Tips&Tricks – All models

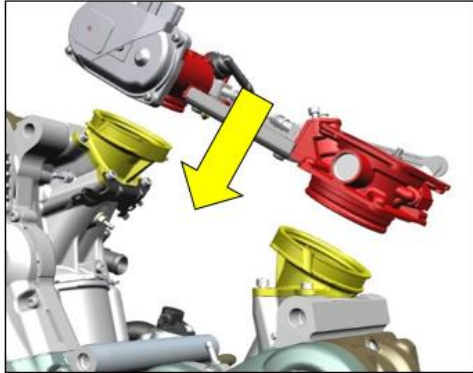
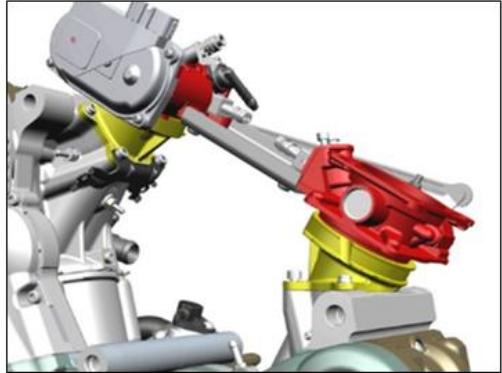
no.	Symptom	Subject	Photo	Notes and Indications - Corrective action
1	<p><u>ONLY</u> <u>Monster 821</u> <u>Monster 1200</u> <u>SuperSport</u></p> <p>Possible engine popping sound during deceleration and/or irregular idling</p>	Airbox		<p>We have received some complaints about a possible engine popping sound during deceleration. The performed analyses have shown that this symptom could be caused by an incorrect installation of the throttle bodies in the relevant intake manifolds (possible deformation of the rubber profile).</p> <p>Therefore, if you find any similar symptoms, we kindly ask you to check the correct installation of the Airbox on the motorcycle and in particular that:</p> <ul style="list-style-type: none"> - throttle bodies are correctly inserted inside rubber intake manifolds, along the whole perimeter; - the rubber profile of the intake manifolds is not deformed. - the 2 fastening ties are correctly positioned in the seat on the intake manifolds <p>Please be reminded that, in order to make throttle body insertion easier on rubber intake manifolds, the use of silicone lubricant or similar product is absolutely necessary.</p> <div data-bbox="1137 676 1608 1050">  </div> <div data-bbox="1630 676 2130 1050">  </div>

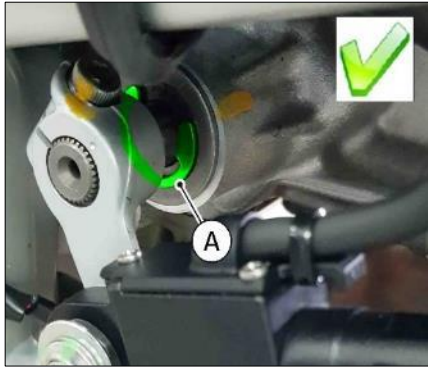
2	<p><u>ONLY</u> <u>Panigale V4</u> <u>(all versions)</u> <u>Streetfighter V4</u> <u>(all versions)</u></p> <p>Introduction of gear selector shaft certification</p>	Gear selector		<p>We have received some isolated reports of a possible loss/absence of the snap ring (A) of the gear selector shaft. We would like to inform you that an additional certification on all Desmosedici Stradale engines between snap ring, washer and crankcase at the outlet of the gear selector shaft has been added along the production line.</p> <p>The first engine serial number with this new certification is ZDM1100WC #001513#.</p> <p>Upon the first workshop service, you are thus invited to check for the presence of the snap ring (A) on all engine serial numbers preceding the one specified above.</p> <div data-bbox="1771 1078 2197 1449">  </div>

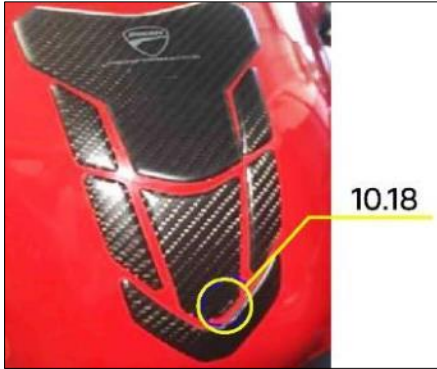
no.	Symptom	Subject	Photo	Notes and Indications - Corrective action
6	<p><u>ONLY</u> <u>Panigale V4</u> <u>StreetFighter V4</u> <u>(all model versions)</u></p> <p>Possible reduction of the clutch fluid level inside its reservoir</p>	Hydraulic clutch control		<p>We received a few claims concerning a reduction of the clutch fluid level inside its reservoir. We would like to inform you that it is not sufficient to carry out the bleeding procedure or top up the clutch fluid inside the reservoir. We suggest, at a preliminary stage, to check:</p> <ul style="list-style-type: none">• the play between the clutch master cylinder and the lever• if the clutch pushrod is worn or damaged in the area of contact with the clutch slave cylinder (ball)• the condition of the clutch slave cylinder protective diaphragm, which must not be torn. <p>According to our analyses, this phenomenon is due to a DOT4 leakage from the primary seal of the clutch slave cylinder (missing fluid in the reservoir builds up in-between the clutch slave cylinder diaphragms); in some cases, this phenomenon is also accompanied by wear of the clutch pushrod. We therefore ask you to replace the slave cylinder with a new part no.19540091D featuring a new gasket in order to prevent the phenomenon described above.</p> <p>If the clutch pushrod is damaged as shown in the figure, replace it as well.</p> <div data-bbox="1227 719 2024 1018"></div>

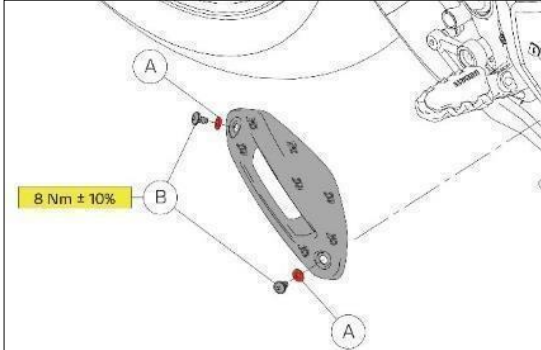
no.	Symptom	Subject	Photo	Notes and Indications - Corrective action
1	<p><u>ONLY</u> <u>Diavel Lamborghini</u></p> <p>Possible indentation of RH and/or LH outer cover of the air conveyor</p>	RH and LH air conveyor covers		<p>We have received some isolated reports about a possible indentation of the RH and/or LH outer cover of the air conveyor.</p> <p>To avoid this phenomenon, it is necessary to position washer (1) 4x14x1 Part no.85240171A between outer cover (2) and carbon air conveyor (3) in the upper fixing point, as shown in the figure.</p>

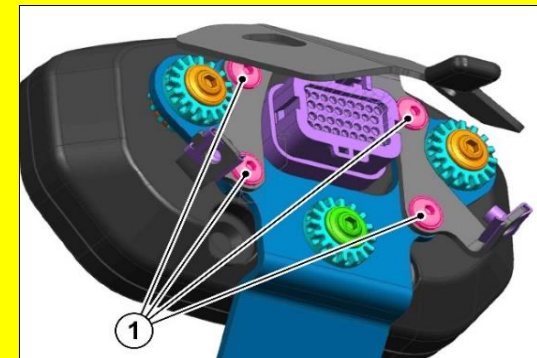
no.	Symptom	Subject	Photo	Notes and Indications - Corrective action
1	<p><u>ONLY</u> <u>Hypermotard 950</u></p> <p>Possible engine hard starting and/or erratic idling</p>	Engine	-	<p>We have been informed about possible engine starting issues and/or erratic idling.</p> <p>Connect the DDS2.0 diagnosis instrument to the motorcycle and:</p> <ol style="list-style-type: none"> 1) if the following errors are present: <ul style="list-style-type: none"> - Error P2303 "horizontal cylinder coil control, open circuit or short-circuit to ground" - Error P2300 "vertical cylinder coil control, open circuit or short-circuit to ground" carry out a coil activation test and proceed with the replacement <u>only</u> in case of a malfunction (always fill in a YouTech service request) 2) in case of no errors stored in memory, fill in a YouTech service request and attach the recording of the following parameters (at idling rpm, from cold to fan switch-on): <ul style="list-style-type: none"> - Injection time correction of horizontal and vertical cylinders (from lambda sensor) - Horizontal and vertical cylinder ignition advance - Vertical and horizontal cylinder injector injection time - Engine speed and engine temperature - A/F offset adaptive parameter for horizontal and vertical cylinders - Air mass flow in the horizontal and vertical cylinders - MAP pressure sensor for horizontal and vertical cylinders - TPS Sensor - Absolute percentage of throttle opening <p>We also suggest you to inspect the intake nipple pipe union connections to MAP sensor and perform a coil activation test with a possible attempt to replace the coil on the cylinder with negative air/fuel adaptive parameter values (close to or higher than 1mg/tdc).</p>

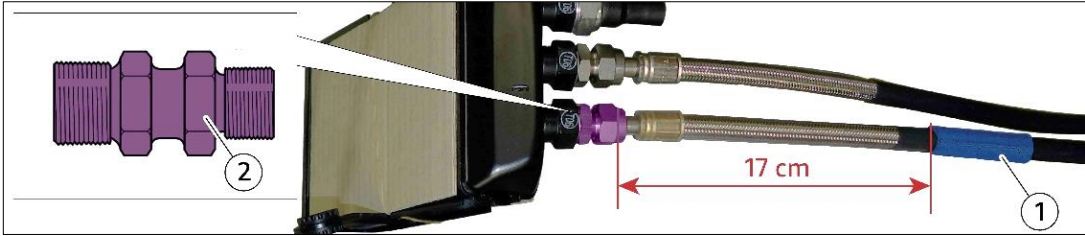
no.	Symptom	Subject	Photo	Notes and Indications - Corrective action
NEW 1	<p><u>ONLY</u> Monster Plus MY21 (937cc)</p> <p>M5x8 screws are missing from the kit supplied with the bike</p>	Kit supplied with the bike		<p>We have received a few reports stating that 4 M5x8 screws (1) part no.77240243C required to fix the headlight fairing support bracket to the instrument panel support bracket are missing from the kit supplied with the motorbike.</p> <p>We would like to inform you that the kits available in stock have all been sorted out.</p> <p>For the headlight fairing assembly procedure and all Pre-delivery operations, please refer to the model introduction bulletin SRV-SRB-21-022.</p>
NEW 2	<p><u>ONLY</u> Monster MY21 (937cc)</p> <p>Standard motorbike lowering and conversion kits now available</p>	Standard motorbike lowering and conversion kits	-	<p>We hereby inform you that the following kits are now available:</p> <ul style="list-style-type: none">- Motorbike lowering kit part no.96280801AA- Motorbike lifting kit part no.96280821AA <p>The kits include the following dedicated components:</p> <ul style="list-style-type: none">• a pair of front fork springs• rear shock absorber spring• side stand• side stand retaining nut <p>Please follow the procedure outlined in the kit or accessories catalogue and the detailed information in the workshop manual.</p>

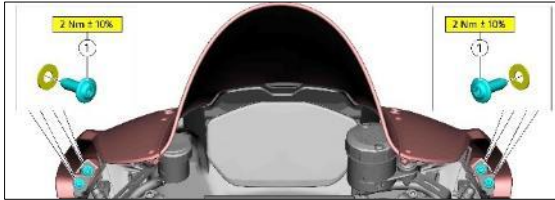
no.	Symptom	Subject	Photo	Notes and Indications - Corrective action
3	<p><u>ONLY</u> Multistrada 950 MY 17-20 Multistrada 1200 MY 15-17 Multistrada 1260 MY18-20 (all model versions)</p> <p>Possible superficial damage to the oil cooler return pipe</p>	Oil cooler pipes		<p>We have received some isolated reports of possible surface damage to the oil cooler return pipe due to rubbing with the top of the coolant radiator, over time. <u>This phenomenon is purely aesthetic and does not affect the correct operation of the system.</u> We inform you that for the models:</p> <p>a) <u>Multistrada 1260:</u> starting from the frame number ZDMAC03AAAKB011354 (on 27/05/2019) the anti-abrasion sheath (1) part no.4601H701A has been introduced on the oil cooler return pipe, positioned at a distance of 17 cm measured from the upper end of the fitting. (This solution is also applicable to all Multistrada 1200 versions Model Year 2015-2017).</p>  <p>b) <u>Multistrada 950:</u></p> <ul style="list-style-type: none"> - starting from the frame number ZDMAD00AAAKB002259 (on 10/05/2019) the anti-abrasion sheath (1) part no.4601H701A has been introduced on the oil cooler return pipe, positioned at a distance of 17 cm measured from the upper end of the fitting; - starting from the frame number ZDMAD00AALB005691 (on 12/03/2020) the longer fitting (2) part no.81510391A has been introduced at the oil return pipe outlet from the cooler.  <p>We ask you to always check the condition of the oil cooler return pipe, and to replace it ONLY if the rubber sheath is damaged and the metallic braided hose can be seen. Follow the assembly notes indicated above according to the reference model. The spare part catalogue has been updated.</p>

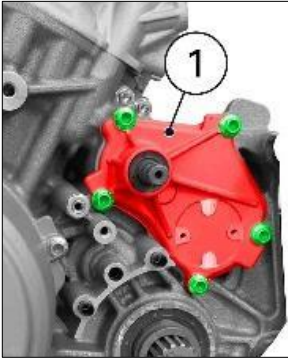
no.	Symptom	Subject	Photo	Notes and Indications - Corrective action																						
10	<p><u>ONLY</u> <u>Panigale V4</u> <u>(all versions)</u></p> <p>Possible failure to display gears on the instrument panel and validation of error P0916 - Gear sensor [Short-circuit to ground or Open Circuit]</p>	Gear sensor	<p style="text-align: center;">Hirschmann</p>  <p style="text-align: center;">Novotechnik</p> 	<p>We have received some reports about the failure to display the gear engaged on the instrument panel and the validation of the error P0916 - Gear Sensor [Short-circuit to ground or Open Circuit]. Based on the analyses carried out, this phenomenon is due to an overheating of the gear sensor.</p> <p>Two types of gear sensors have been installed on the Panigale V4 family, depending on the Model Year (suppliers: Hirschmann and Novotechnik), which differ both for the type of wiring and the magnet placed inside the selector drum. <u>The two gear sensors are NOT interchangeable at all.</u></p> <p>For the motorcycles featuring the Novotechnik gear sensor, a new stronger sensor is available as a spare part, which avoids the phenomenon described above. For the motorcycles featuring the Hirschmann gear sensor, refer to CR200 (SRV-TSB-20-012 bulletin). We therefore invite you to first check the type of sensor installed on the motorcycle and then, as a corrective action, follow the table below.</p>

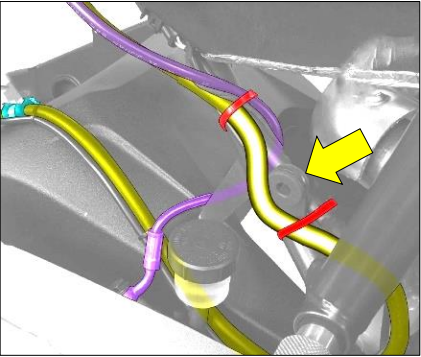
no.	Symptom	Subject	Photo	Notes and Indications - Corrective action
19	<p><u>ONLY</u> Panigale V4 MY21</p> <p>Error "P0919 - Gear sensor plausibility" with MIL warning light turning on and/or failed display of the engaged gear on the instrument panel</p>	Error "P0919 - Gear sensor plausibility"	-	<p>If the error "P0919 - Gear sensor plausibility" occurs, <u>do NOT replace the gear sensor.</u></p> <p>It is necessary to check that the engine control unit software version is updated, then access the "Settings" section and activate the "<u>Reset of the final drive adaptive parameters</u>".</p> <ul style="list-style-type: none">CCP Enabling/DisablingDQS adaptives resetIdle control adaptives resetIdle speed engine operation modeKnock sensor adaptives resetReset gearsReset of the transmission adaptive values

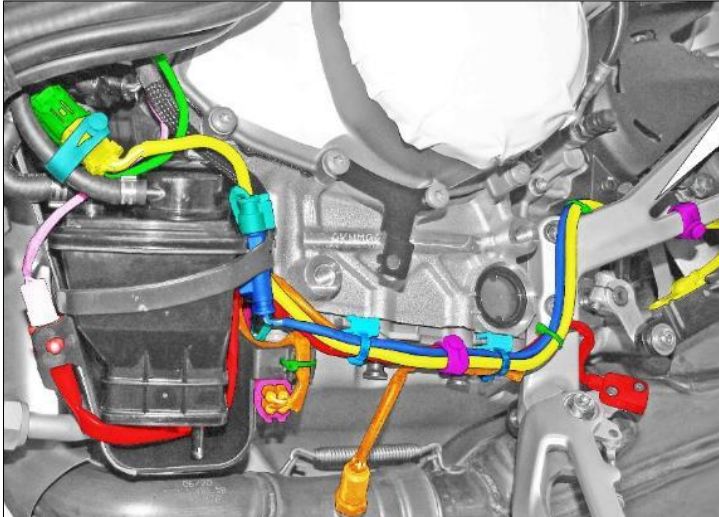
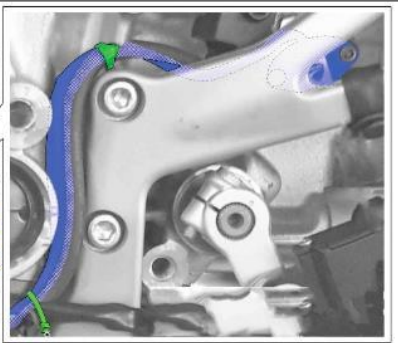
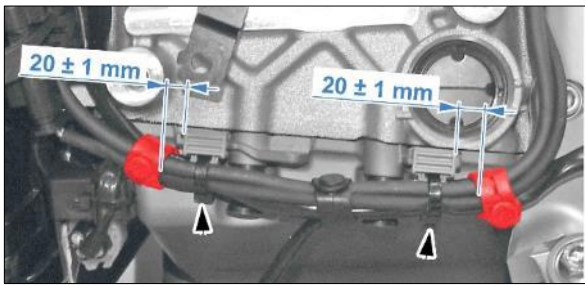
no.	Symptom	Subject	Photo	Notes and Indications - Corrective action				
1	<p><u>ONLY Scrambler 800 (all model versions and MY, excluding Desert Sled model version)</u></p> <p>Precautions when routing the rear brake calliper hose</p>	Rear brake hose	-	<p>We have found that sometimes, during maintenance operations, the rear brake calliper hose is not correctly positioned along the frame.</p> <p>Make sure that the rear brake calliper hose (yellow), passes outside the left side cover mounting bracket with respect to the bike centreline and is fixed with the two self-locking ties (red) as shown in the figure.</p> <p>The operation of inspection and possible repositioning is very simple and involves the disassembly of the left side cover only.</p> 				
2	<p><u>ONLY Scrambler 1100 (all model versions)</u></p> <p>Assembly precautions Bracket accessory kit for side panniers Part no.96781361A</p>	Bracket accessory kit for side panniers Part no.96781361A		<p>Due to a supply error, you may find brackets for soft side bags inside the accessory kit and the presence of a pair of non-compliant M10X45 screws as they are partially threaded instead of completely threaded, as shown in the figure.</p> <p>We ask you to always check that all the kit components are present and correct before installing them and, if the screws are not correct, order the 2 screws M10X45 part no.77242713C (the parts in stock have been reclaimed).</p> <table border="1" data-bbox="1173 895 2063 1098"> <thead> <tr> <th data-bbox="1173 895 1617 935">NON-COMPLIANT Screw M10X45</th> <th data-bbox="1617 895 2063 935">COMPLIANT Screw M10X45</th> </tr> </thead> <tbody> <tr> <td data-bbox="1173 935 1617 1098"></td> <td data-bbox="1617 935 2063 1098"></td> </tr> </tbody> </table> <p>We would also like to inform you that there is a label on the kit box, and at the top right it bears numbers indicating the progressive number and the year of manufacture. The kits that may include the 2 non-compliant M10X45 screws and therefore need to be inspected before proceeding with the installation are numbers "19053" and "19064".</p> 	NON-COMPLIANT Screw M10X45	COMPLIANT Screw M10X45		
NON-COMPLIANT Screw M10X45	COMPLIANT Screw M10X45

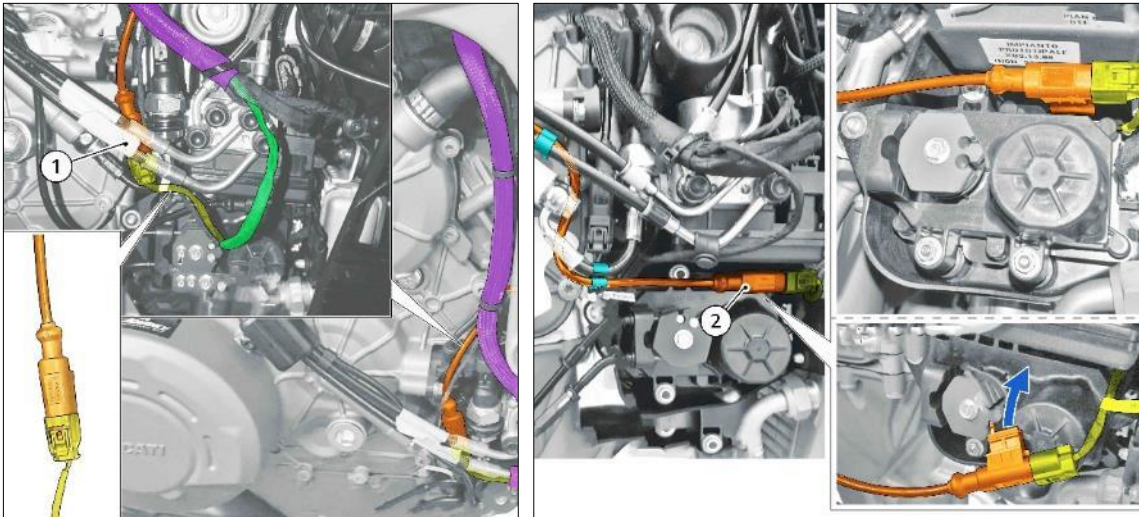
no.	Symptom	Subject	Photo	Notes and Indications - Corrective action
1	Updated layout of motorcycle wiring	Wiring	-	<p>We would like to inform you that the layout of the side stand cable - gear sensor cable - Ducati Quick Shift cable - lambda sensor cable and of the gear sensor connector and cable at the lower crankcase, on the left side of the bike (as shown in the figure) has been updated starting from frame number ZDMFA00AALB003932.</p>   <p>Before installing the wiring cover, apply two L=39mm button ties respecting the dimensions shown in the figure:</p>   <p>We ask you to respect the new layout of the cables and the gear sensor connector in case of servicing of the mentioned parts.</p>

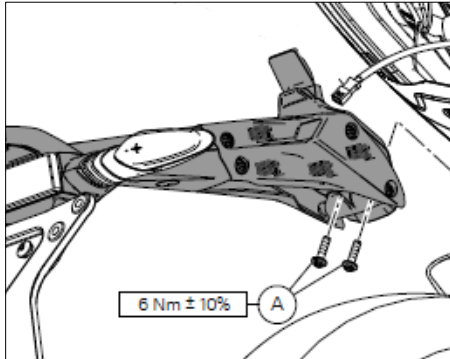
no.	Symptom	Subject	Photo	Notes and Indications - Corrective action
4	Assembly precautions Anti-theft system kit part no.96680811A	Anti-theft system kit Part no.96680811A		Please, be reminded that if anti-theft system kit Part no.96680811A is installed for model Streetfighter V4, the anti-theft system/DMS support set (additional wiring with anti-theft system fastening support bracket) Part no.96680941BA must be purchased at the same time, as specified on the spare part catalogue "compatibility" section.
5	Possible flashing of low fuel light	Low fuel light	-	<p>We have received some isolated claims about the flashing of low fuel light; this phenomenon is due to an electric problem of the thermistor resulting in the validation of Error P0460 - Fuel level sensor [Short circuit to positive or Open circuit].</p> <p>Please, fill in a YouTech service request and then replace the component by ordering a new spare one Part no.69928751A.</p>
